**BEFORE AN EXPERT PANEL  
SOUTHERN SEAWALL RENEWAL PROJECT**

**FTAA-2510-1118**

**STATEMENT OF EVIDENCE OF JENNIFER HELEN HART AND AMY LOUISE SHEPPARD (COASTAL PROCESSES, ENGINEERING AND DESIGN) ON BEHALF OF WELLINGTON INTERNATIONAL AIRPORT LIMITED**

Figure 1: Eastern end of Eastern Bank Remediation

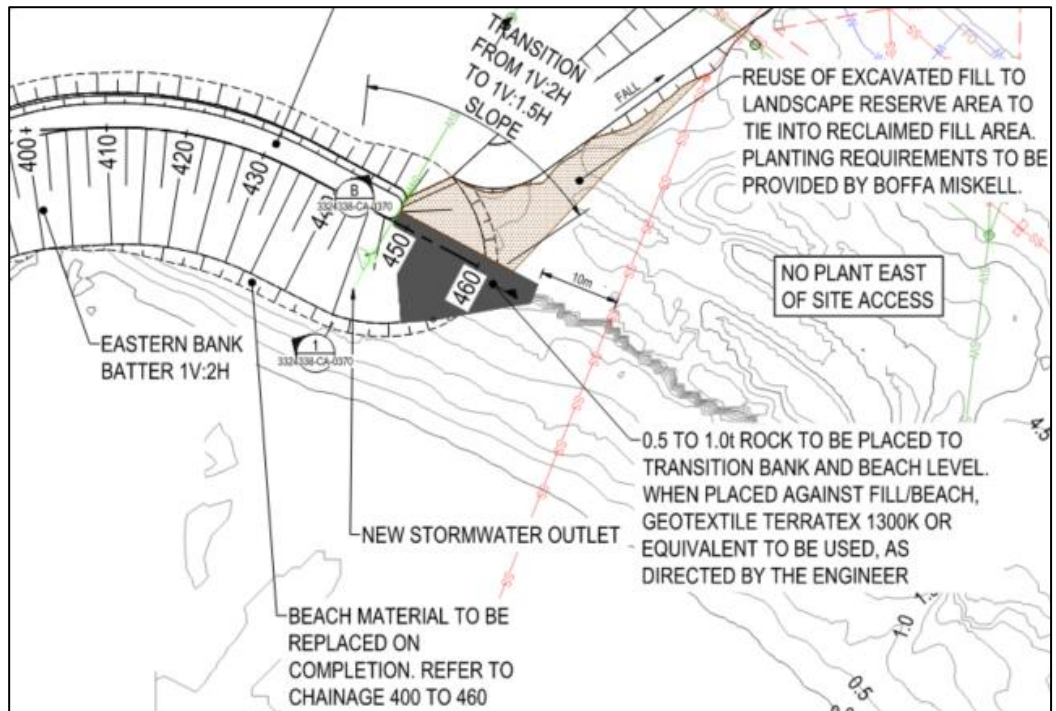
15. GWRC's section 53 comments express uncertainty about whether the Eastern Bank Remediation and the eastern end of the Southern Seawall could cause end-effects erosion at Moa Point Beach if the eastern edge forms a hard 90-degree junction that causes substantial wave reflection.

16. GWRC considers post-construction monitoring necessary to identify and respond to any such effects:
  - (a) Dr Iain Dawe recommends annual beach survey monitoring for five years to monitor for any unexpected changes in Moa Point Beach as a result of the seawall extension; and
  - (b) Dr Dawe also recommends that, after five years of monitoring, an assessment report is prepared that summarises the findings of the monitoring and identifies any remedial action that could be undertaken.

18. The Eastern Bank Remediation design also incorporates a tapered rock section on the upper beach at the eastern end of the revetment (refer to **Figure 1** for this detail). This tapered rock section is placed over geotextile.

19. The tapered rock section bridges between the revetment armour rock and the bank to the east, providing a smoother transition in the revetment footprint (i.e. avoiding a 90-degree intersection with the existing bank) and easing the change in slope from the milder revetment slope to the subvertical bank face. This minimises end effect erosion by providing an extended rock slope to help dissipate wave energy and reducing any theoretical reflection of waves from a 90-degree face laterally along the beach (although noting that waves approach and reflect perpendicular to the shoreline at this location). This design addresses GWRC's main concern.

20. While this design addresses GWRC's comment, the proposed consent conditions also require post-construction inspection by a coastal/maritime engineer, annually for the first two years and five yearly thereafter (CA.26), with reports to be made available to GWRC on request (CA.29).

22. In conclusion, we consider the beach monitoring conditions sought by GWRC are not necessary as the tapered rock section included in the design addresses GWRC's main concern, and the proposed consent conditions already provide for a post-construction inspection regime.

Figure 2: Section through Kororā underpass showing present day tide and storm-tide levels, 2080 storm-tide level and existing ground surface (dashed line)

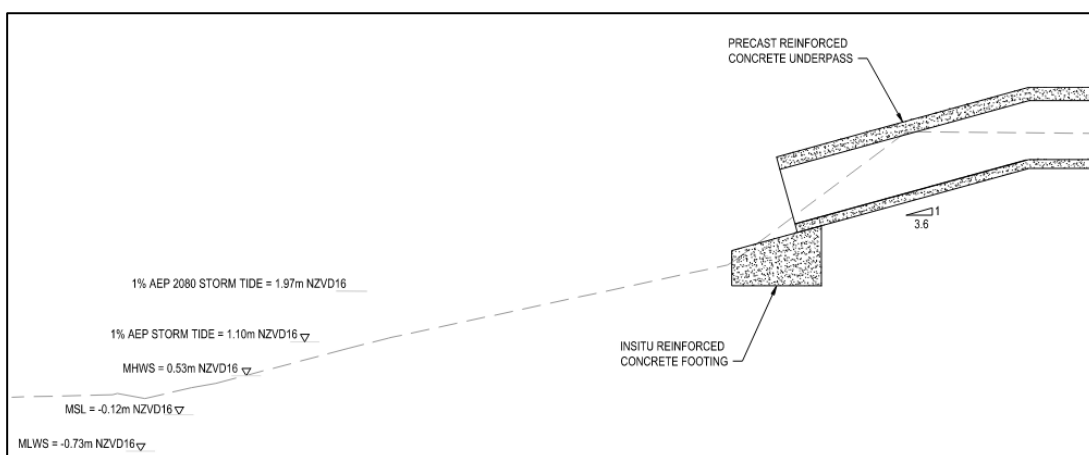
29. The Guardians of the Bays' section 53 comments query whether increased sea level and storm swells have been considered with the position and placement of the Kororā tunnel/underpass at the Stage 1 Kororā Colony, and ask how the underpass will be maintained with continued erosion and possible inundation of the tunnel with gravel.

31. The seaward end of the proposed Kororā underpass is located above the 1% Annual Exceedance Probability (AEP)<sup>4</sup> storm-tide level for both the present day and with projected Relative Sea Level Rise to 2080 (Shared Socioeconomic Pathway 5-8.5H+ projection).

32. The seaward end of the underpass is approximately 0.7m above the present day beach level, providing clearance for accumulation of gravel on the beach without blocking the underpass entrance.

33. The seaward end of the underpass is supported on a reinforced concrete footing, founded in the greywacke bedrock underlying the gravel beach. This will provide a resilient foundation for the culvert if the surficial beach gravels are eroded in the future.

34. A concept sketch of the seaward end of the proposed Kororā underpass, with present day and future water levels and present day beach levels, is shown in **Figure 2**.
